Downtown Carpark Site Development

FTAA-2512-1158

2.0 Technical Specialist Memo – Senior Development Engineer

Subject: Regulatory Engineering Review
Resource Consent Application – Fast Track Application
BUN60460864/EPA: FTAA-2512-1158
Lower Hobson Street, City Centre

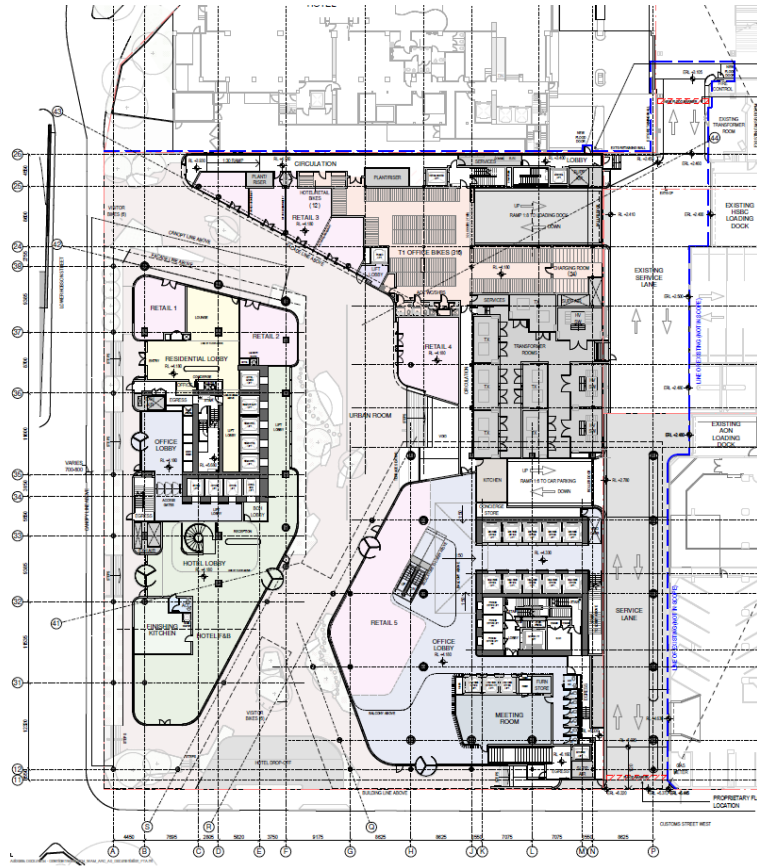
Most building spaces have a finished floor level of 4.18 m RL which allows at least 500 mm of freeboard from floodwater. Floodwater in this area is modelled to be up to 3.63 mRL as a result of post development with the 3.8degree climate change

Non-Habitable floor levels

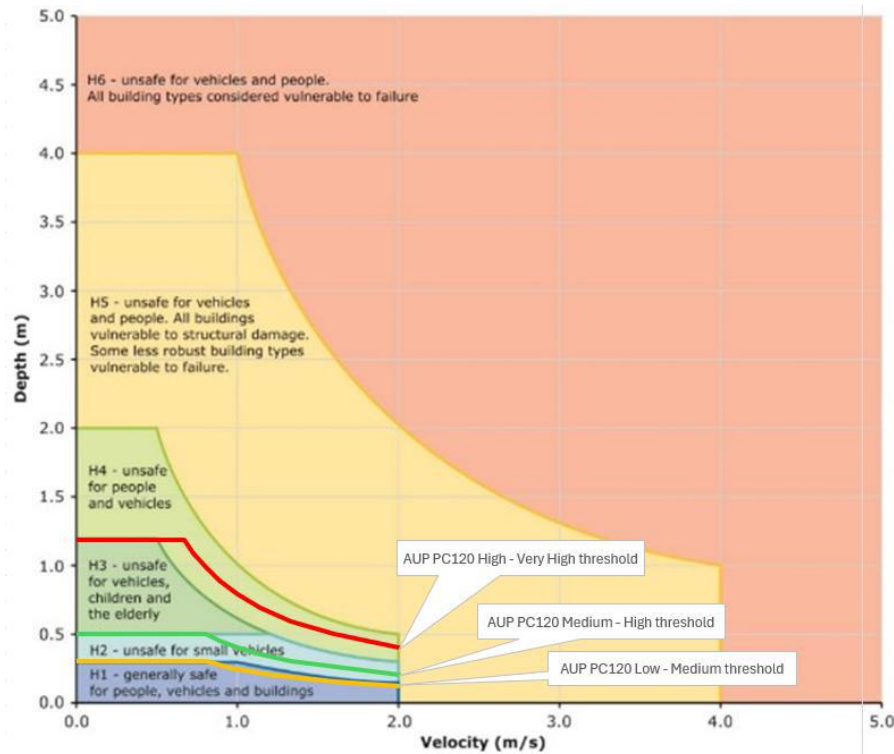
The property design incorporates measures that fully mitigate the flood consequences to non-habitable floor levels up to the 1% AEP flood scenario with allowance for the 3.8 degrees of warming high emission future climate scenario. All units at floor Level 00 (set at 4.18 mRL) and above are situated above the predicted flood levels (3.63 mRL in Lower Hobson Street) and allow a minimum freeboard of 500 mm or are located outside the floodplain.

Figure 2.1: Coastal inundation overlays for the 1% AEP event with different relative sea level rise magnitudes (source: Auckland Council GeoMaps).

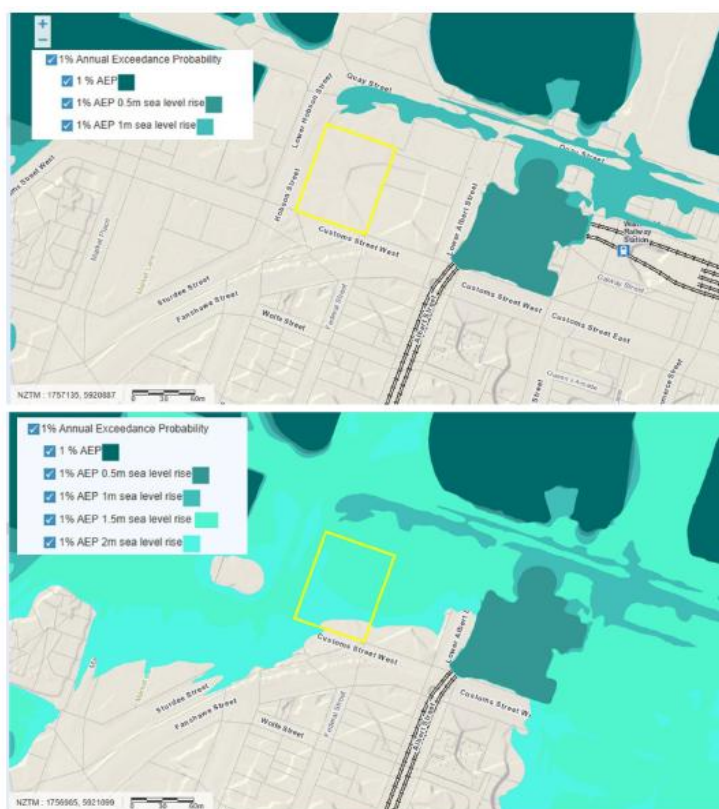
Based on GeoMaps the site is not located within the 1% AEP coastal inundation area with 1.0 m of sea level rise however is located within 2.0 m of sea level rise.

The revised AUP E36 for notified PC120 also defines new natural hazard areas, with rules according to the sensitivity of development. Based on the PC120 hazard area definitions, the proposed development is in **Coastal Hazard Area 3** (1.0 – 1.5 m RSLR). According to Table E36.3.1B.1 development in Coastal Hazard Area 3 within existing urban areas is *potentially tolerable* for sensitive activities and *acceptable* for less-sensitive activities such as parking and loading.

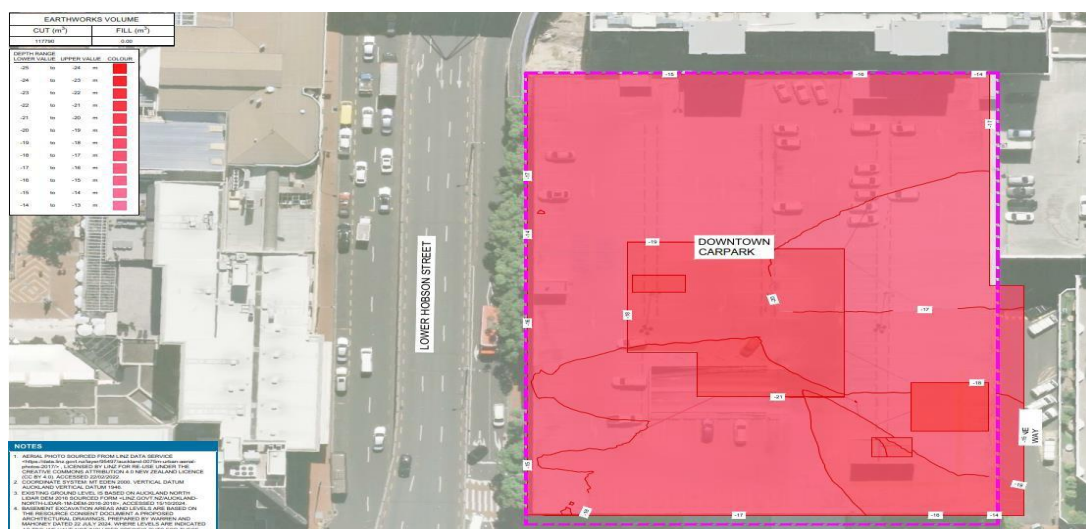
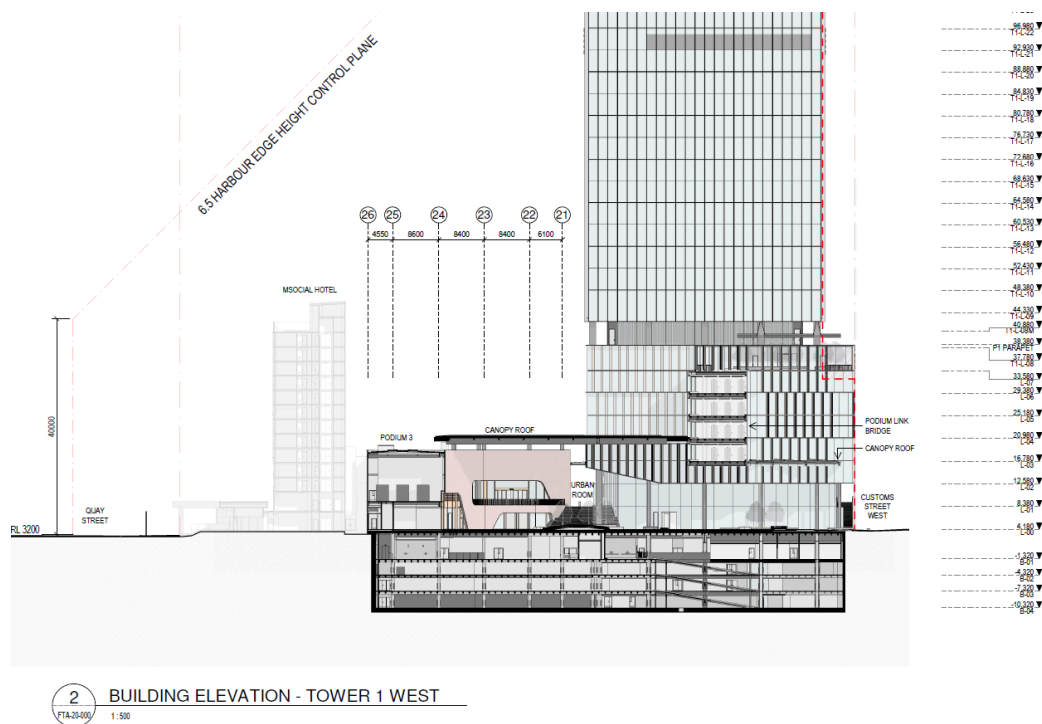
The proposed development is situated in a coastal inundation hazard area subject to future coastal inundation exposure with sea level rise of between 1.0 and 1.5 m. The proposed design mitigates significant coastal inundation risk through the design elements of floor level elevation for the ground floor and a flood barrier to the Service Lane and basement car parking area, with the resultant risks being low to negligible for at least the next 100 years.

Residual risks have been identified and quantified. There are possible adaptation options to manage residual risk to the basement with suitable flood barrier design and maintenance information and subsequently adopted appropriate flood management plan and emergency response protocol.
